**UNITED STATES  
NUCLEAR REGULATORY COMMISSION  
WASHINGTON, D.C. 20555-0001**

**SAFETY EVALUATION REPORT  
NAC INTERNATIONAL  
MAGNASTOR® STORAGE SYSTEM  
DOCKET NO. 72-1031  
AMENDMENT NO. 5**

Figure 4-1: PWR Four-Zone Preferential Loading

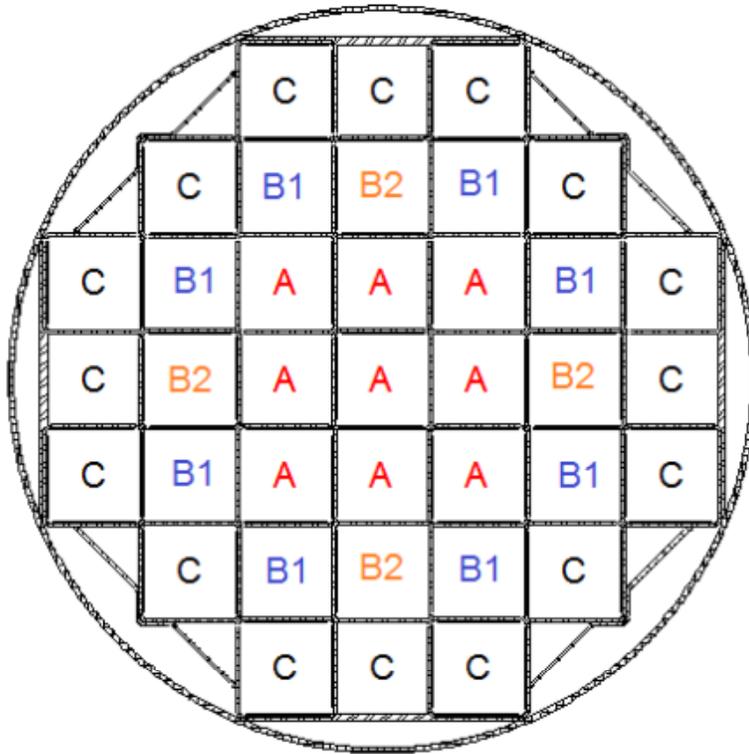
The proposed PWR fuel preferential loading configuration requests accommodation of up to 37 PWR fuel assemblies with some fuel assemblies at a reduced cooling time using a loading pattern shown in Figure 4-1, and heat load limits as shown in Table 4-1 below. The maximum heat load limits are 35.5 kW for the low burnup fuel ( $\leq 45$  GWd/MTU) and 33.725 kW for the high burnup fuel ( $> 45$  GWd/MTU).

The staff reviewed the thermal evaluation and finds that the proposed loading pattern with the hot fuel located at the outer zone will remove the heat more significantly, and that the calculated temperature of 630°F is far below the limit of 752°F. Therefore, the staff determines that the thermal analysis of the PWR minimum reduced cool time fuel assembly is bounded by the thermal analysis of the standard PWR fuel assembly not only for the vacuum drying operations, but also for other short-term operations. The staff concludes that the proposed loading pattern of the 37 PWR minimum reduced cool time fuel assembly is acceptable per the thermal requirements listed in 10 CFR Part 72.

In order to envelop fuel assemblies with heat loads higher than 959 W, which is the bounding heat load for uniform loading, the applicant proposed a four-zone preferential loading pattern as shown in Table 4-1 and Figure 4-1, above. Preferential and uniform loading patterns still limit the total cask heat load to 35.5 kW.

off-normal, and accident conditions when the proposed preferential loading profile (Figure 4.1-2 in SAR) for the 37 PWR minimum reduced cool time fuel basket is used.
